**DECLARATION OF JOHN LARGE  
IN SUPPORT OF 2.206 PETITION  
BY FRIENDS OF THE EARTH**

**L&A REF: R3218-A2 03 27 13**

**CLIENT: FRIENDS OF EARTH**

**TUBE WEAR IDENTIFIED IN THE SAN ONOFRE REPLACEMENT STEAM GENERATORS  
MITSUBISHI REPORTS UES-20120254 REV.0 (3/64) AND L5-04GA588(0) TOGETHER WITH  
OTHER RELEVANT INFORMATION**

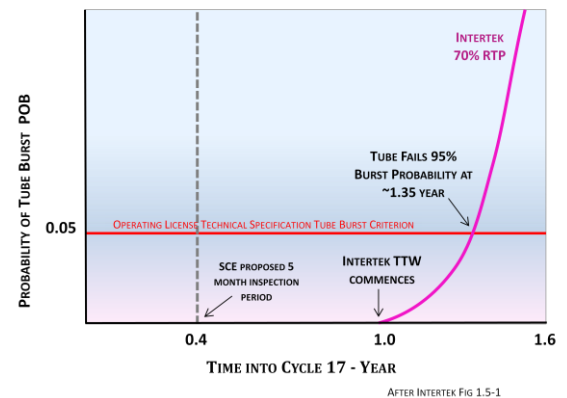
- i) Intertek's projected trends <p37, Figure 1.5-1> show that even at 70% reduced power output, the restarted Unit 2 RSGs would have a remaining operational life of about 1.35 years before the tube burst criterion is exceeded;
- ii) at which time (skipping the SCE nominated inter-inspection period of five months), the RSGs would have to be taken out of service and those tubes (TTW, TSP- and AVB-to-tube wear) failing the Operating License TS would have to be plugged and isolated from pressurized service operation, along with other zones of tubes requiring preventative plugging to suit the changing thermal-hydraulic flow regimes in the RSGs.

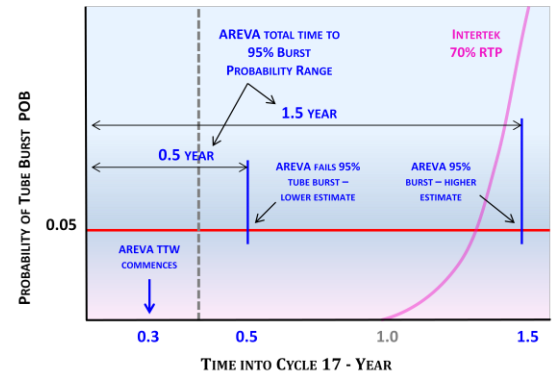
v) Intertek's projections do not compare at all favorably with the same periods evaluated by AREVA OA.<sup>7</sup> For AREVA (show [THUS](#)):

- a) the period whilst the AVBs are 'slackening off' before TTW commences is ~0.3 year compared to 1 year by Intertek; and
- b) similarly, the equivalent total time to tube burst being AREVA in the range of 0.5 to 1.5 year compared to ~1.3 year Intertek

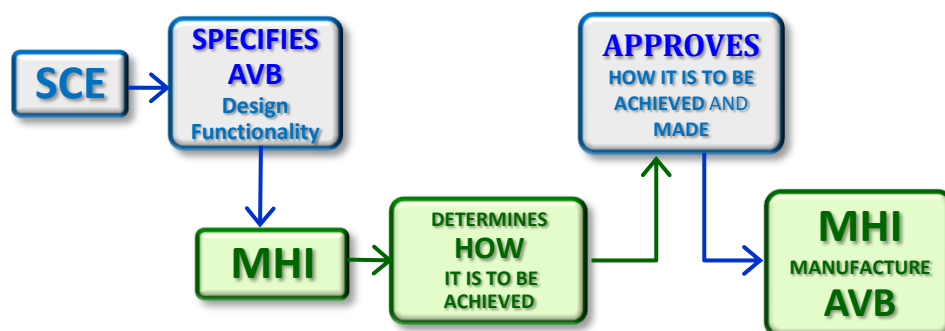
**AVB Design and Manufacture:** RCA reproduces a short text extract [p8, ¶2] of the SCE *Certified Design Specification SO23-617-01 Rev 3*:

- b) “. . . 3.10.3.5 . . . The Supplier shall **develop** and submit for Edison’s **approval an Engineering and Fabrication Gap Control Methodology** describing control of an effective “**zero**” **tube-to-flat bar gap**, gap uniformity and parallelism of the tube bundle in the **out-of-plane direction** prior to tube fabrication.”

This specification is of interest in that it clearly states (although note that it is presented in isolation by RCA) that there should be no pre-load force acting on the tubes, and hence no friction force between the AV bar and tube to inhibit movement in the IP direction. The specification also requires the ‘*gap statistical size . . . shall not exceed 0.003 inch*’ which effectively restrains *out-of-plane* (OOP) motion of the tube.

FIGURE 2 ARRANGEMENTS ACCORDING RCA SCE/MHI COMBINED AVB DESIGN TEAM SPECIFICATION

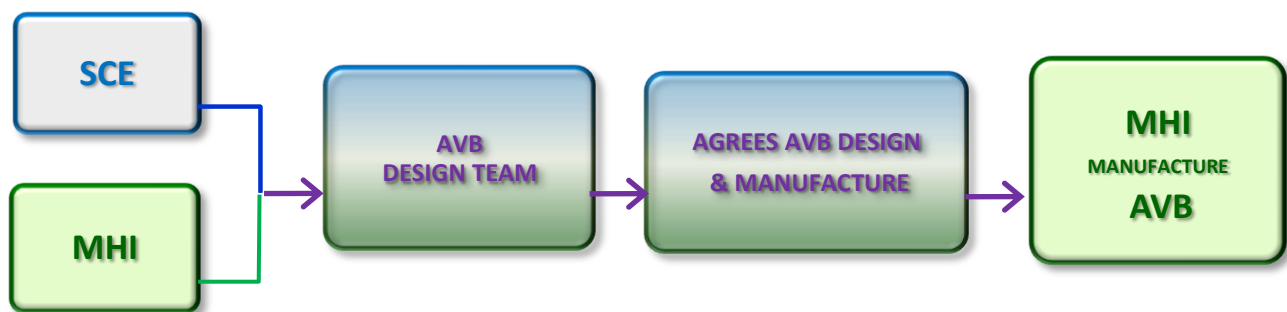
This undated modification to the contractual arrangements, as claimed by RCA, considerably changes the role and responsibility of SCE in the AVB design and manufacturing processes:

Interpretation of these arrangements suggests that SCE had much hands-on involvement with decisions relating to the detailed design and manufacture of the AVB. In this joint role SCE was involved at all stages of the design that arrived and approved the incorrect design option for the AVB restraint and, moreover, it was also involved in the flawed method of manufacture which resulted in warped AVB bars that were subsequently corrected for the later manufactured Unit 3 RSGs (incidentally, reducing the quite fortuitous pre-loading of some of the AVB-to-tube contact points that were, as it transpired to be, the most obvious reason for the delay the onset of TTW in Unit 2).

**DIAGRAM 1 TIME LINES FOR SELECTED DESIGN ACTIVITY TOPICS**

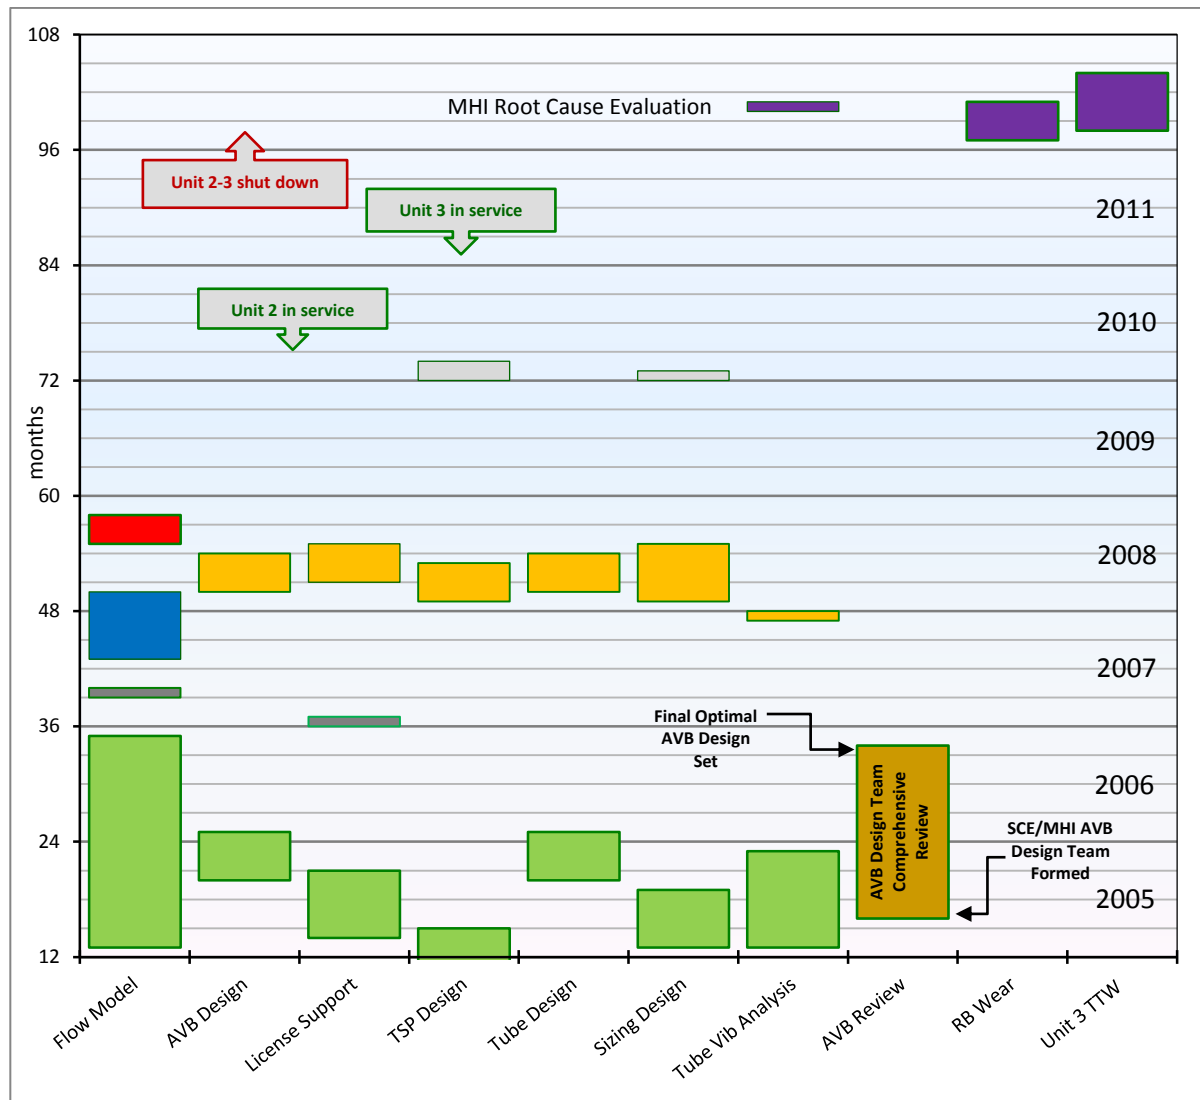
As evident from **DIAGRAM 1**, most of the design activity ■ seems to have been settled by 2005 to late 2006. Note that the critical topics *AVB Design* and *Review*, and *Tube Vibration Analysis* seem to have been closed out early in 2005-06, although the flow modeling continues through with revisions being raised through to late 2008.
